**Edwin I. Hatch Nuclear Plant
Request for License Amendment
Extended Power Uprate Operation**

Page Change Instructions

The proposed changes to the Plant Hatch Unit 1 and Unit 2 Facility Operating Licenses and Technical Specifications are incorporated as follows:

**Facility Operating License Proposed Change
and
Technical Specifications Proposed Changes**

Figure 3.4.9-1 (page 1 of 1)
Pressure/Temperature Limits for
Inservice Hydrostatic and Inservice Leakage Tests

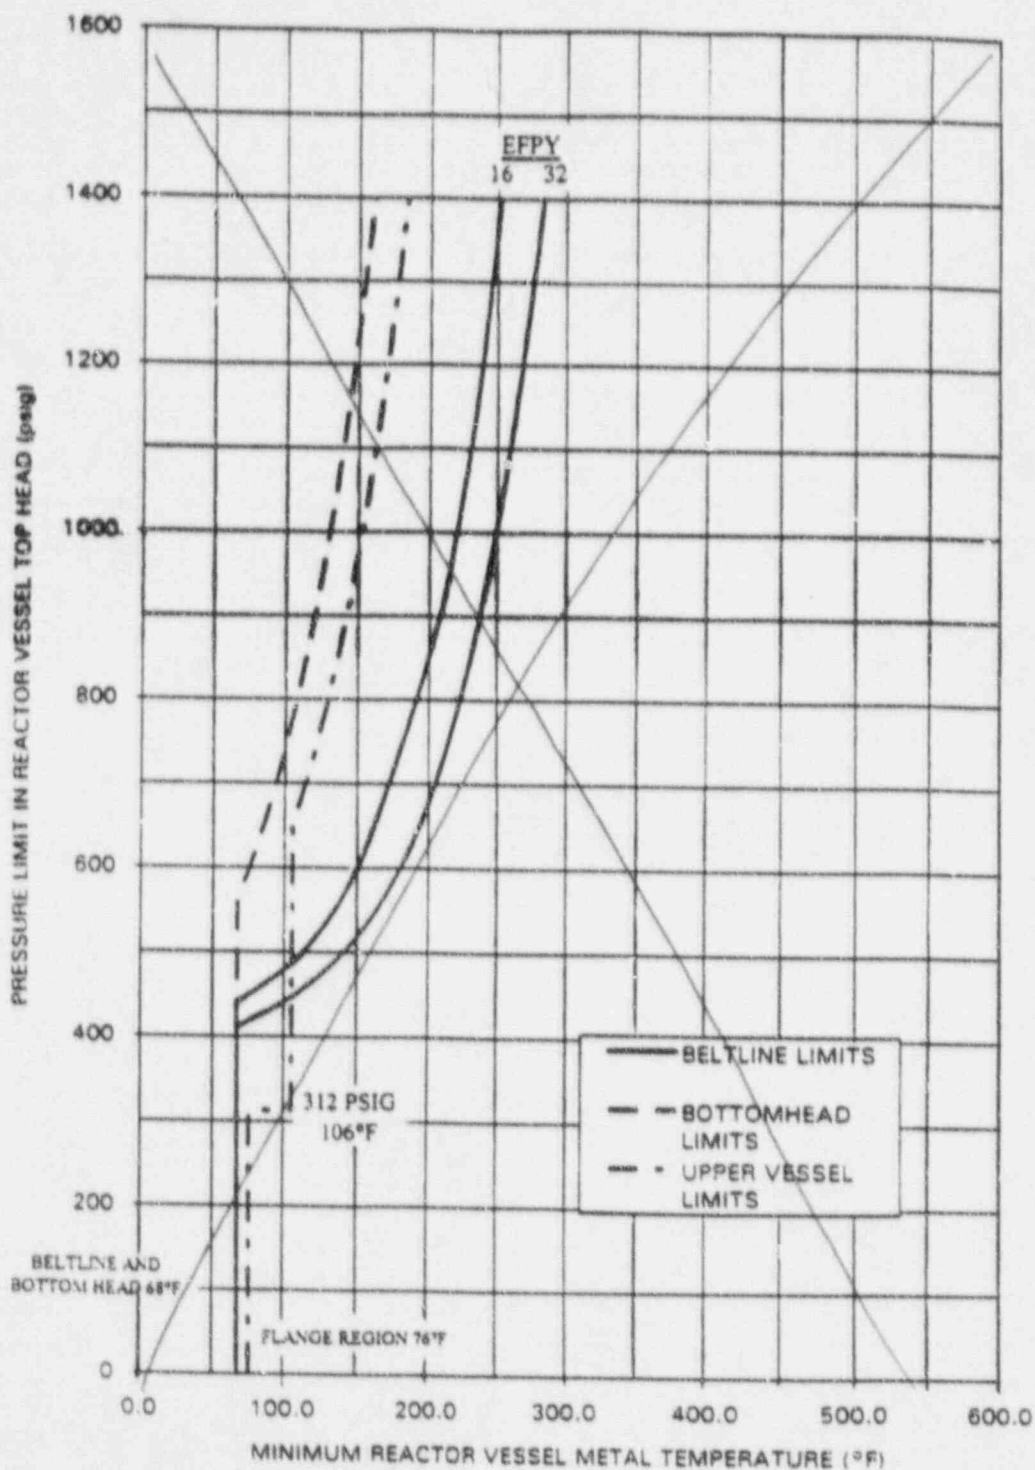
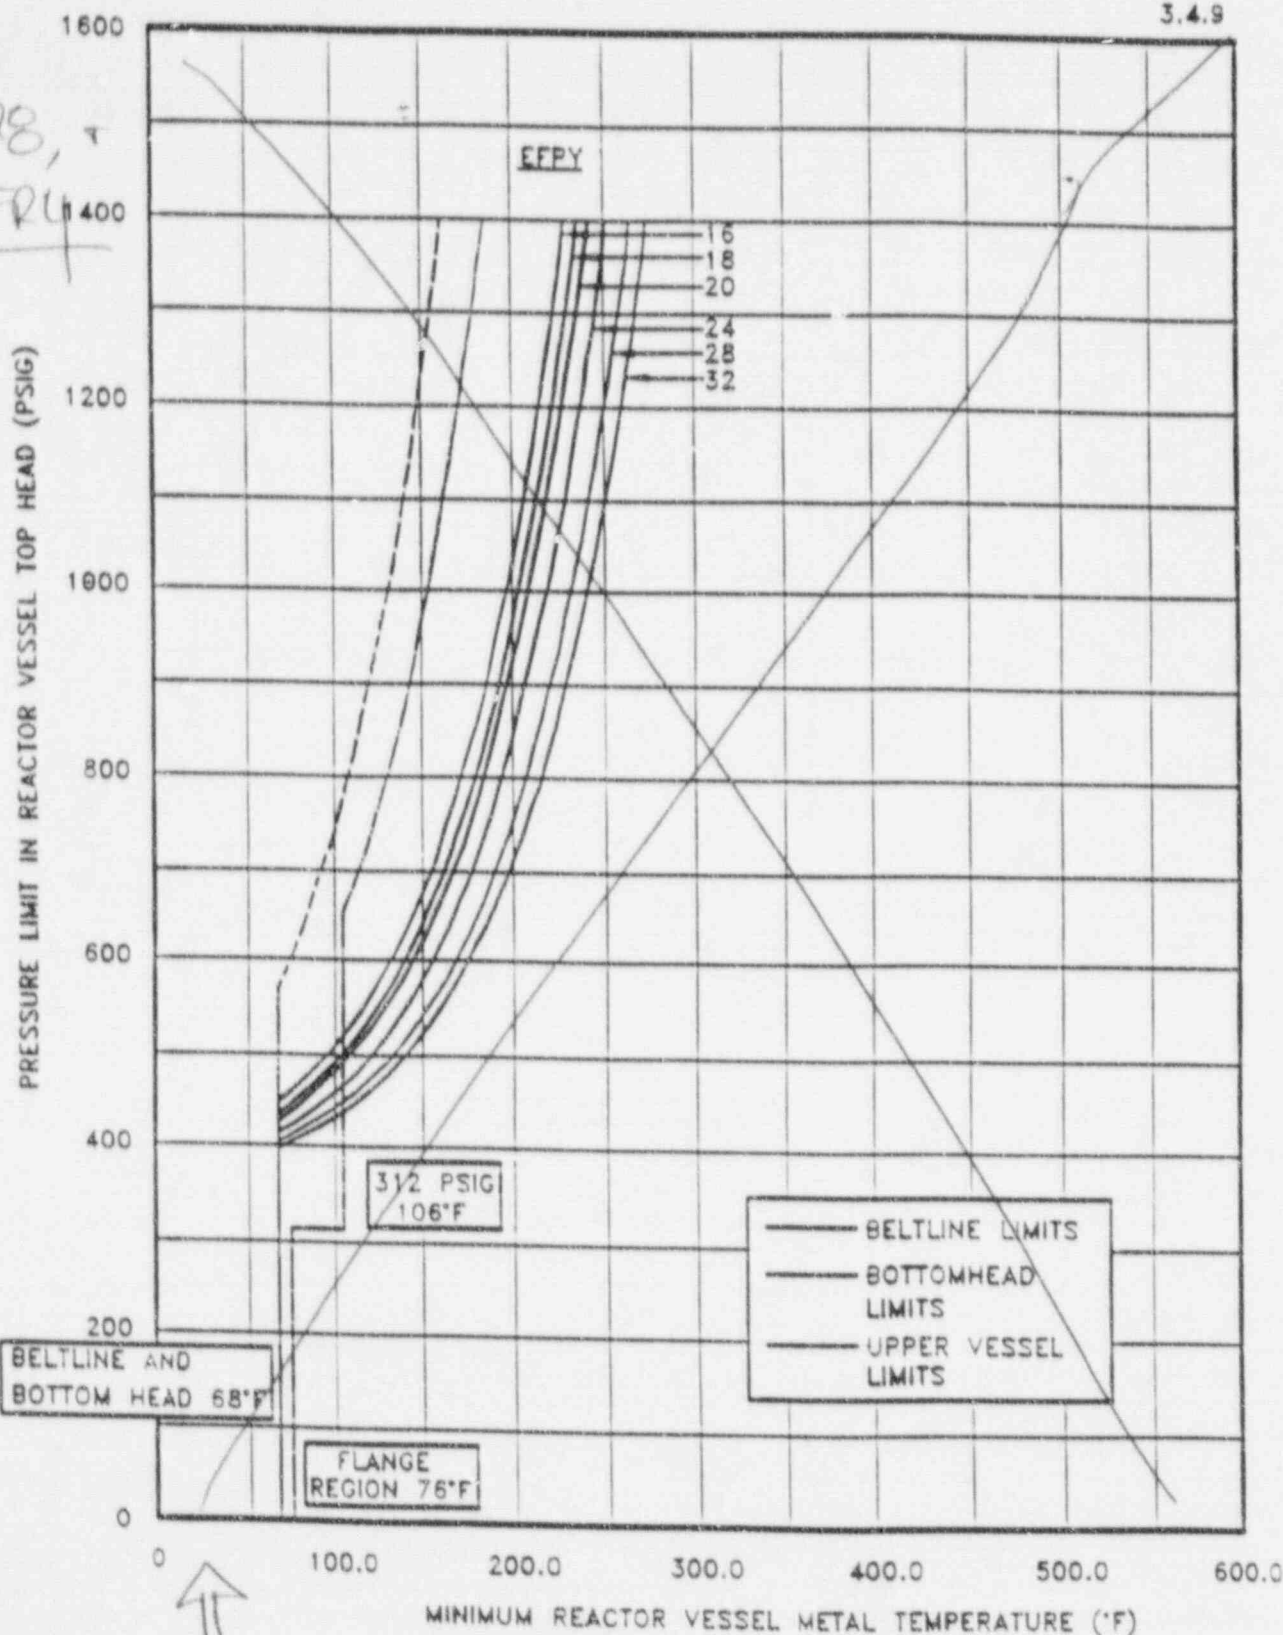
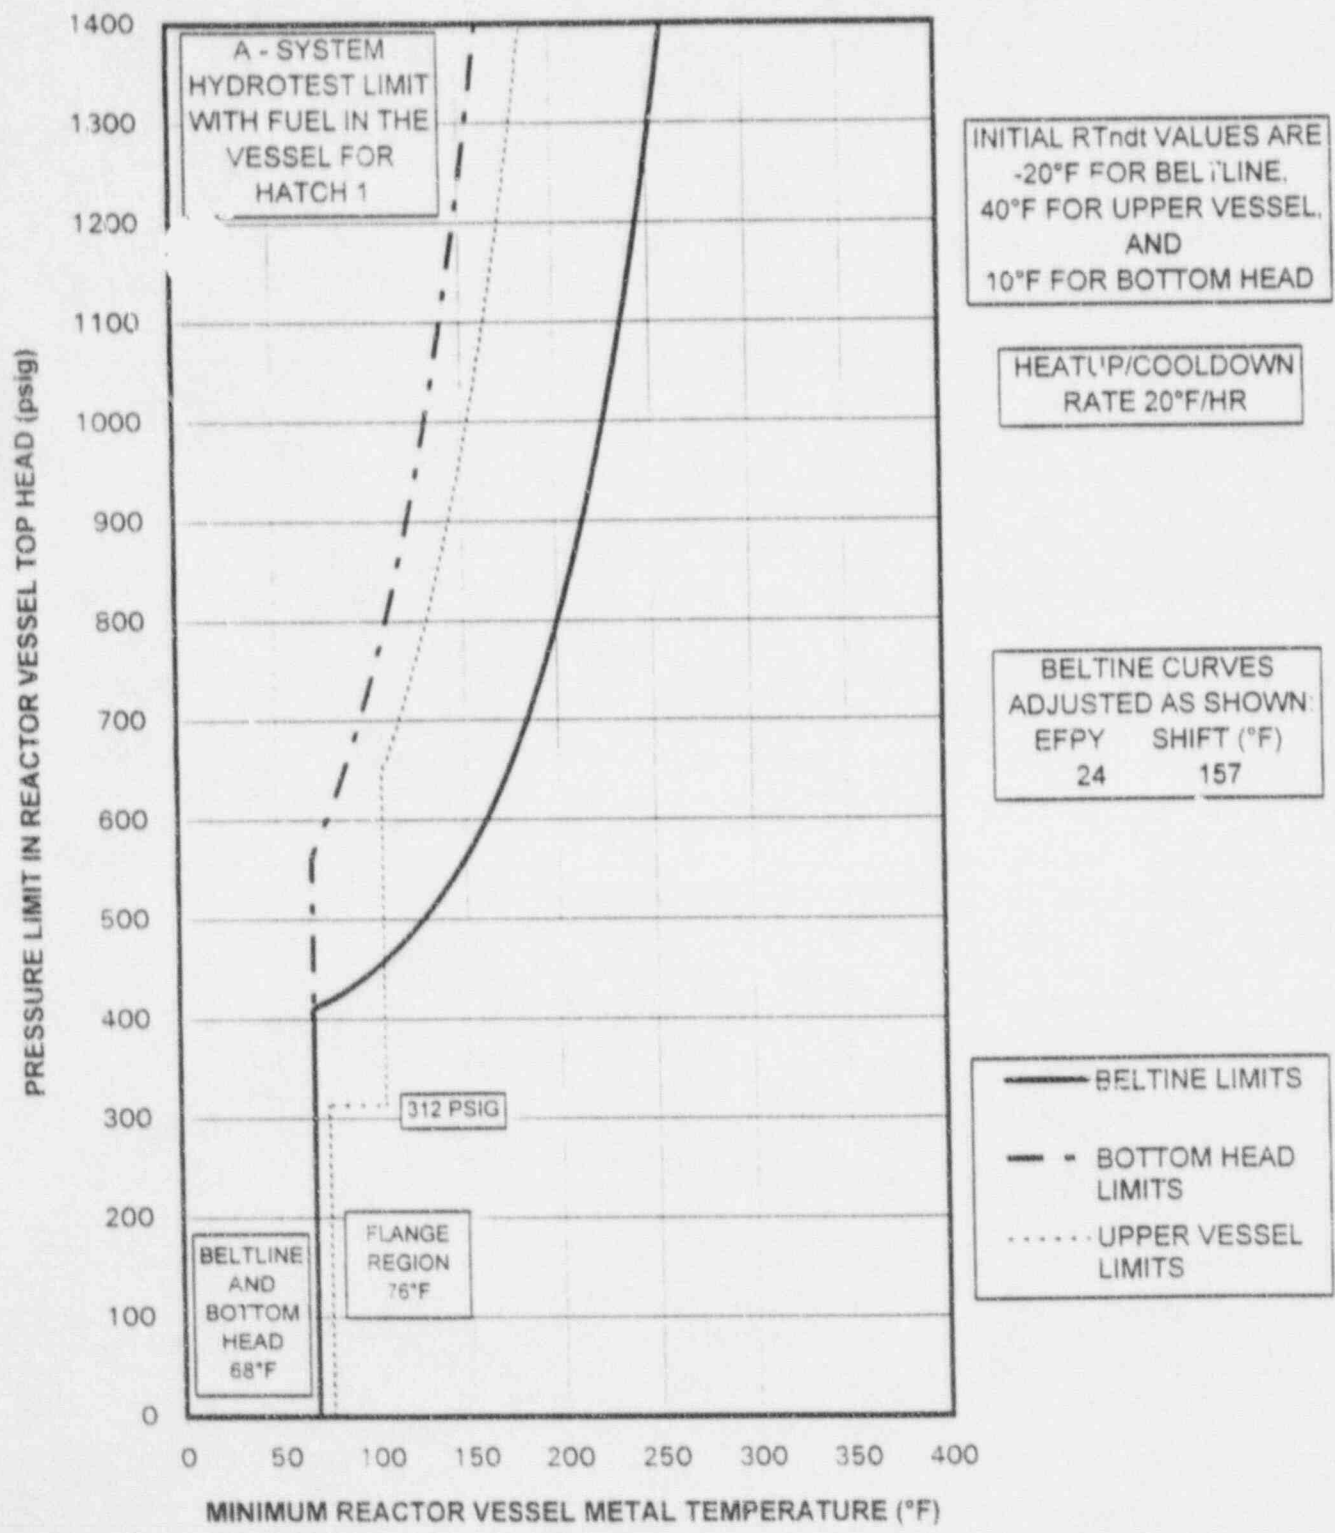
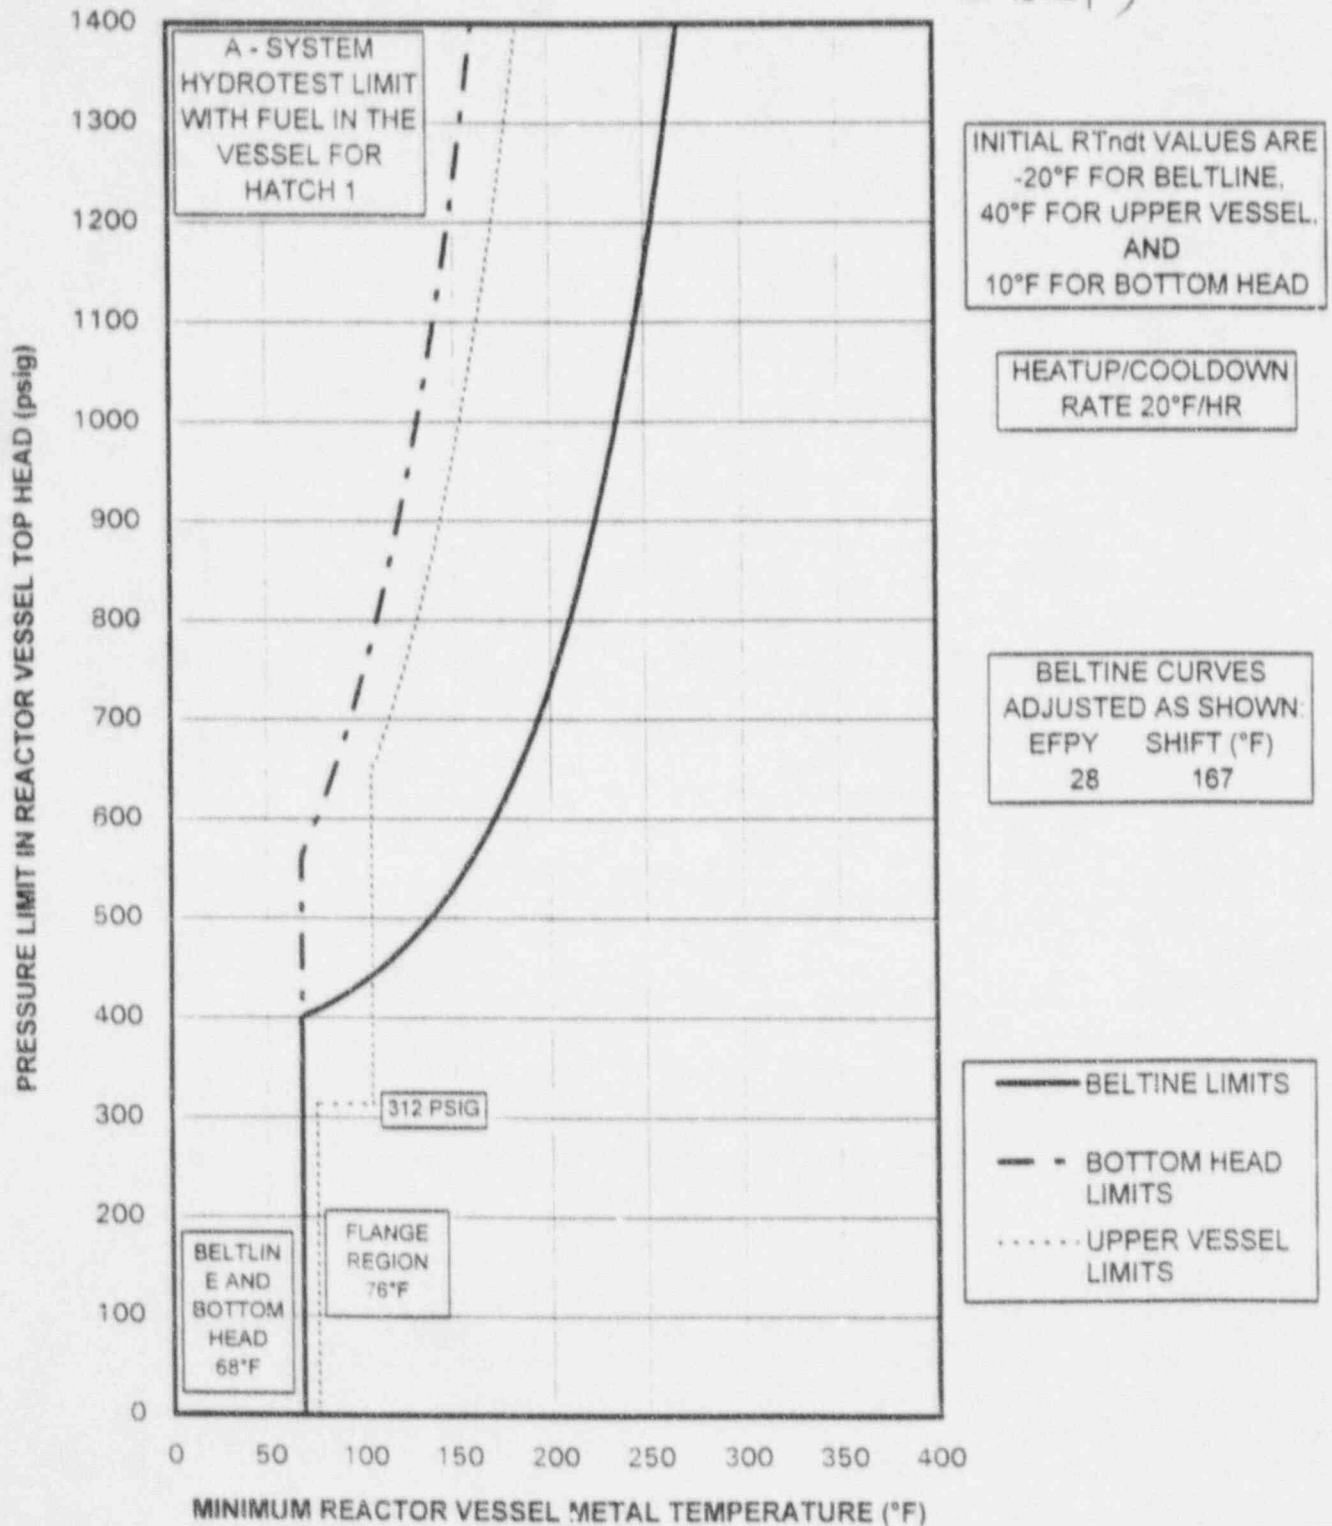
DELETE — SEE PROPOSED FIGURE ATTACHED

Proposed Figure

Figure 3.4.9-1 (Page 1 of 1)
